ADDENDUM: **ONE**

PROJECT TITLE: **ENTRANCE GATE RENOVATIONS - GATES 2, 3, AND 4**
Francis Marion University
State Project No.: H18-9583-SG-E

FROM: McMillan Pazdan Smith Architecture - Columbia
Sanders Tate, Office Director
1316 Washington Street, Columbia SC 29201
state@mcmillanpazdansmith.com

C3
A331
SHORT PIER WITH LOGO
1" = 1'-0"

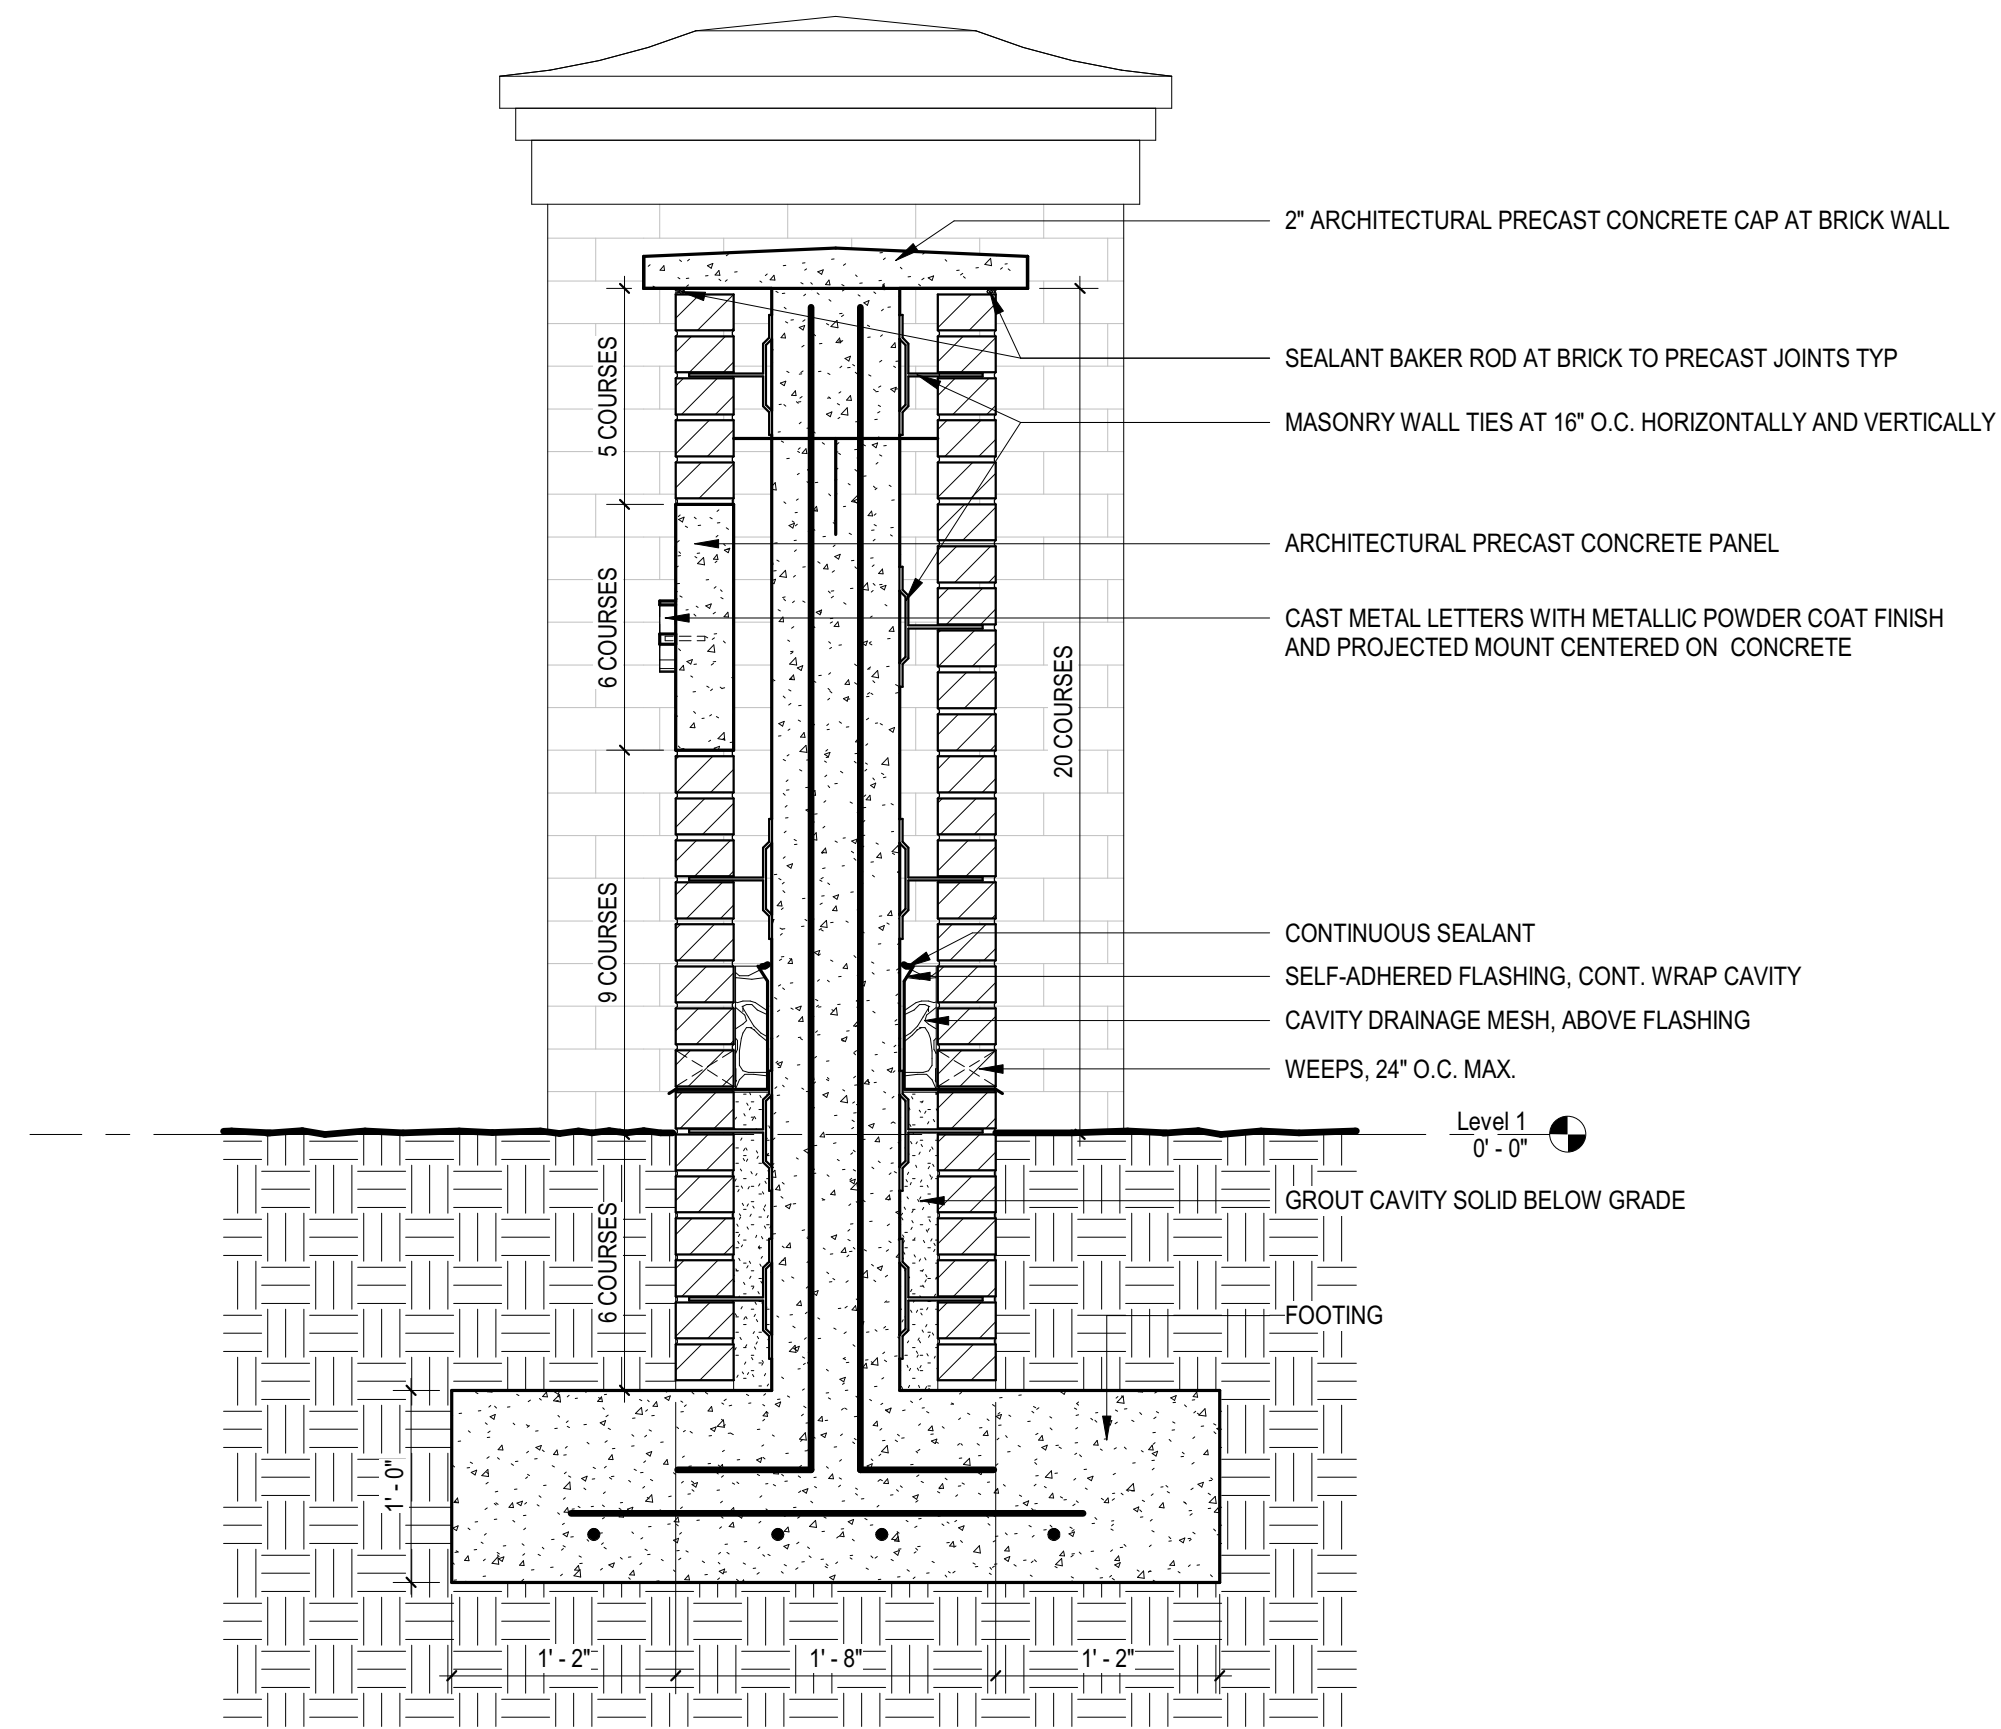
See attached new wall section sheet for revise details C5/A331, C3/A331, C2/A331, A5/A331, A3/A331, A2/A331.
